EASTERN REGIONAL POWER COMMITTEE

MINUTES OF 21st PROTECTION SUB-COMMITTEE MEETING HELD AT ERPC, KOLKATA ON 17.07.2014 (THURSDAY) AT 11:00 HOURS

i. Tripping of 220 kV lines from STPS (WBPDCCL) on 04/04/14.

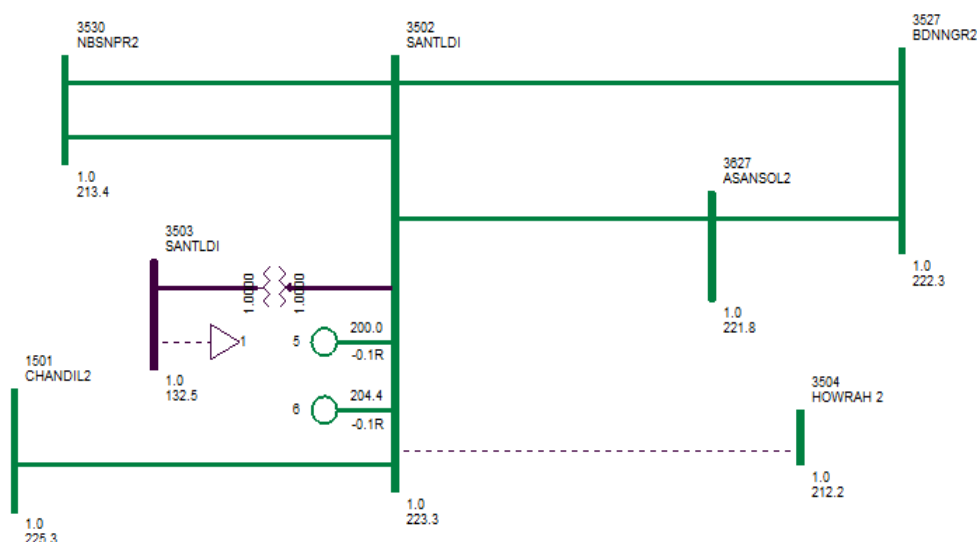
- 1) Tripping of 220kV STPS-Bidhannagar as relay indication shows B-phase fault from STPS end while Y-B Ph faults at Bidhannagar end may also be explained.

PCC felt that O/C setting at 75% on an important interstate tie line is appeared to be at lower side and advised JSEB to increase the over current relay setting to 100%. PCC also advised WBPDCCL to share the O/C relay settings of STPS end with JSEB.

2) 400kV Angul – JITPL-I tripped at 00:32 Hrs of 04.07.2014 due to R- N fault.

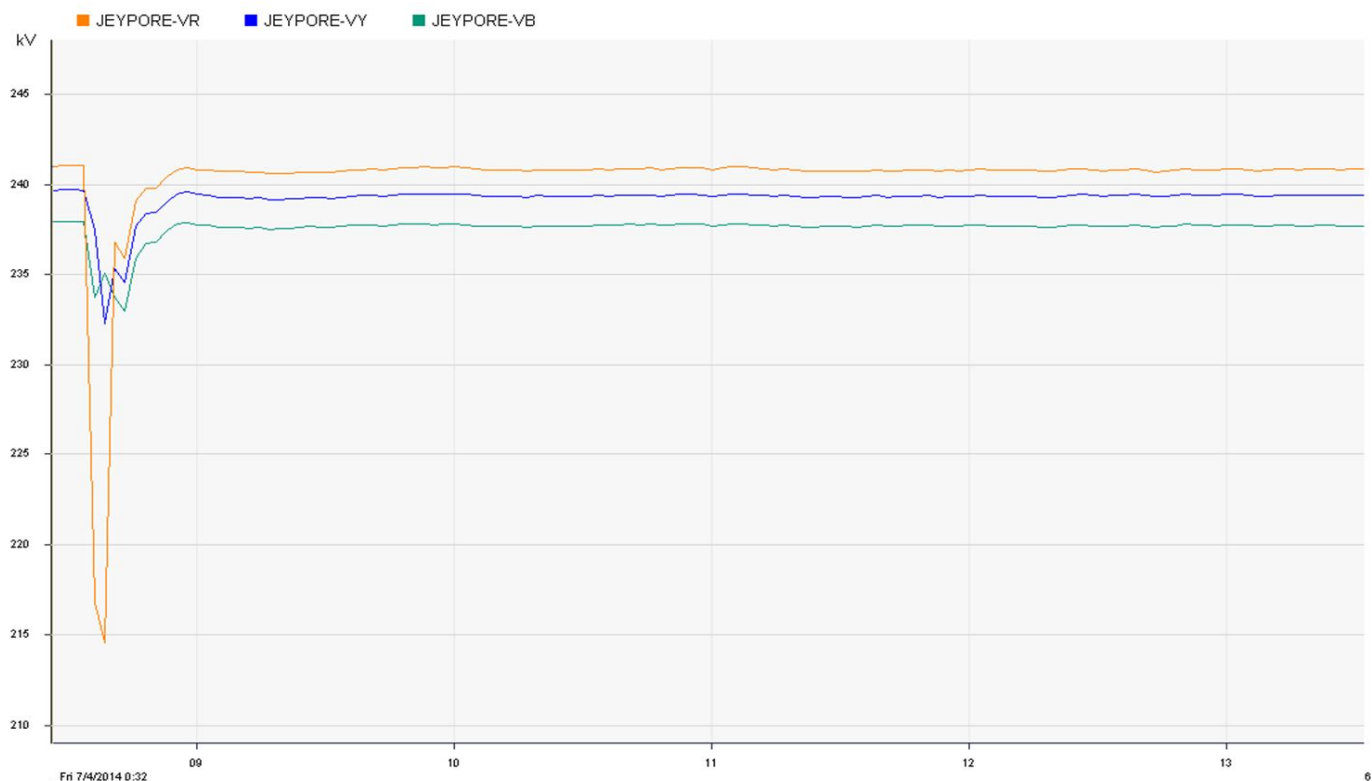
- From the PMU plot of 3-Ø voltage of Jeypore, it can be observed that, there was 26kV dip in R-Ø voltage and the fault got cleared instantaneously (within 100ms).
- There was no indication of auto-reclose operation in the said line for the above fault.

Powergrid explained that code was received for Direct Trip (DT) instead of Permissive under-reach trip. Therefore, Auto-reclosure did not take place at Angul end.
